Saab 9-3 - Loss of coolant | HELLA

Engine code: B284.

Loss of coolant

Figure 1

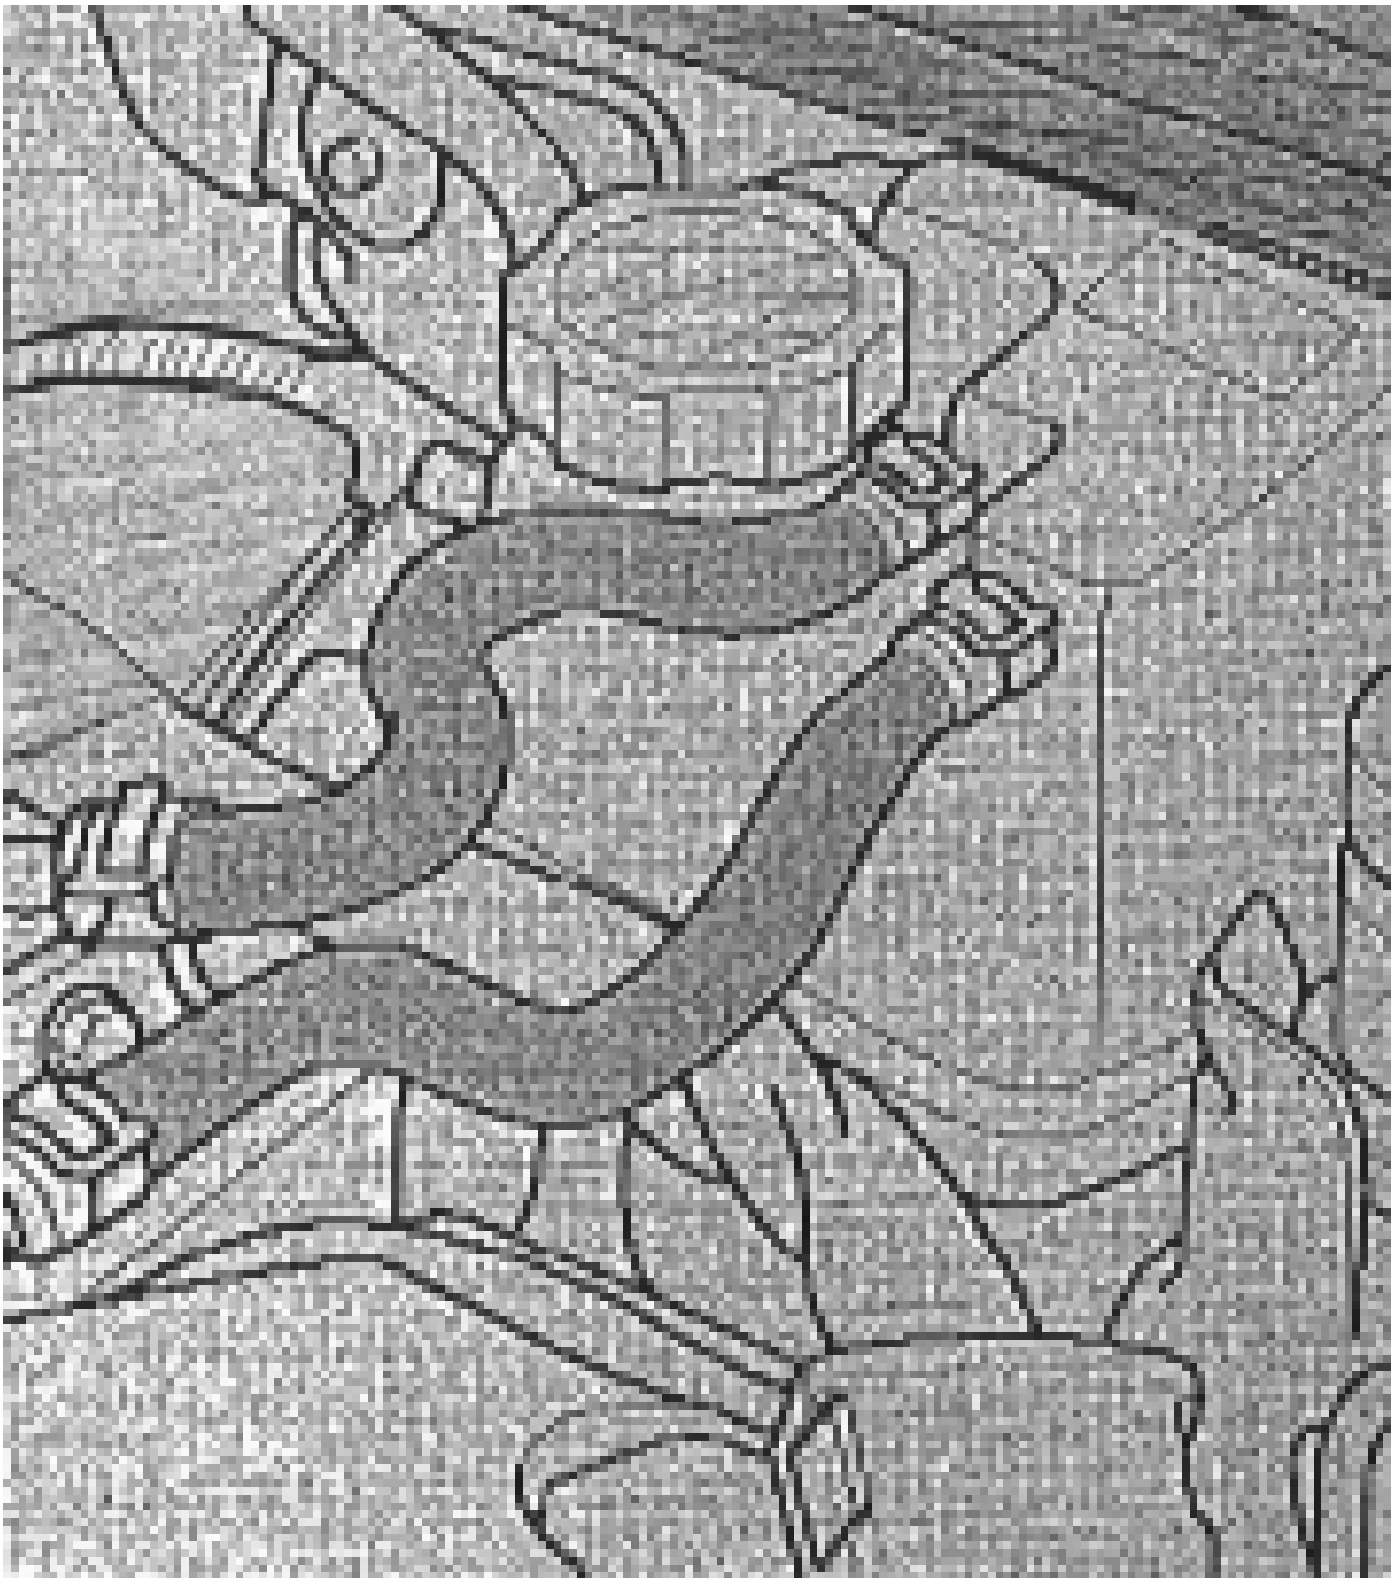
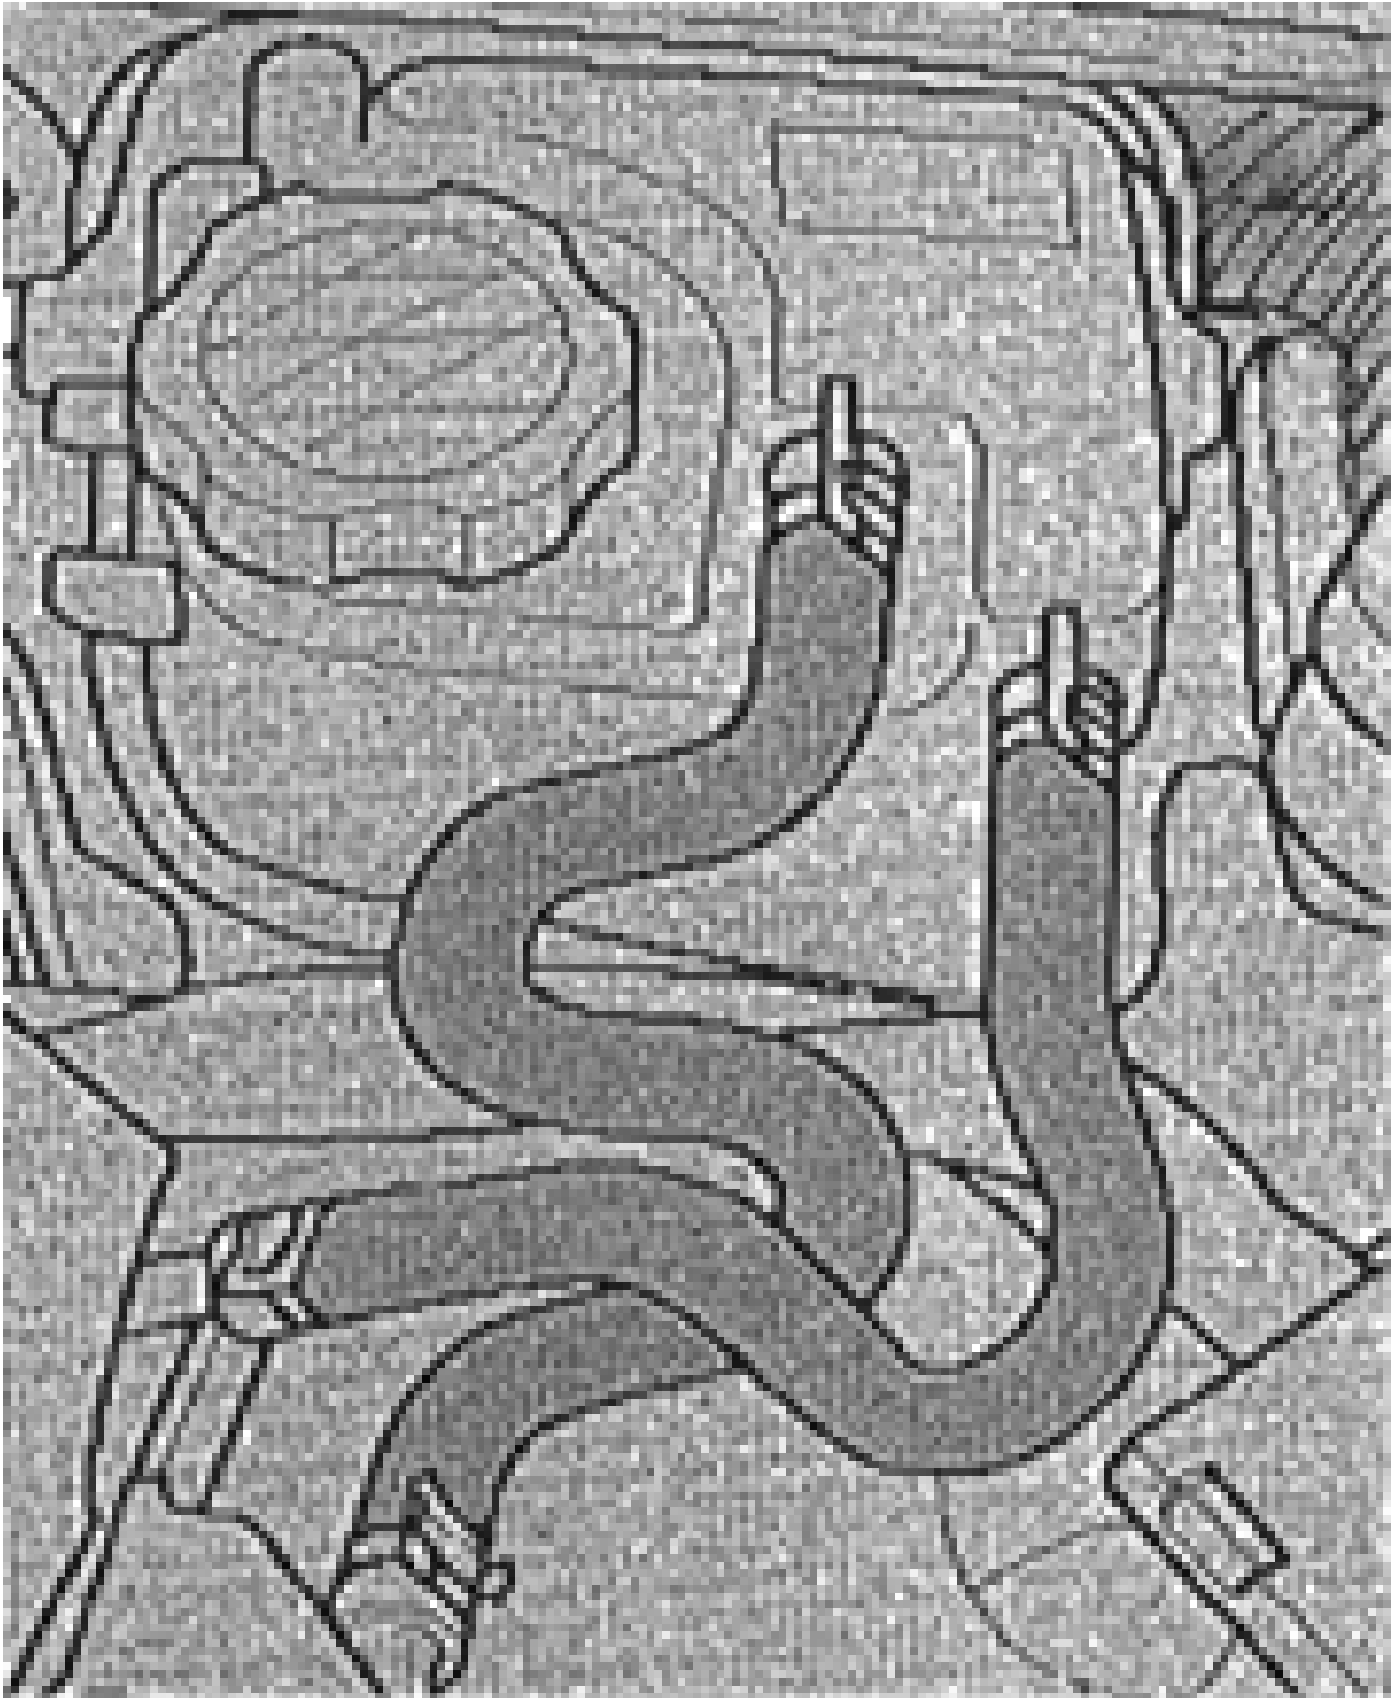
In the case of the above-mentioned vehicles, problems can arise because of loss of coolant. The cause of this can either be a defective coolant expansion tank or damaged engine coolant hoses on the coolant expansion tank.

The positioning of these components (Figure 1) is located very close to the turbo charger, which means that material fatigue can result because of the hot ambient temperature.

In order to remedy this, the coolant expansion tank is to be replaced and the hoses of the coolant expansion tank are also to be replaced / repositioned.

The car manufacturer provides modified coolant hoses for this specific purpose (See Figure 2).
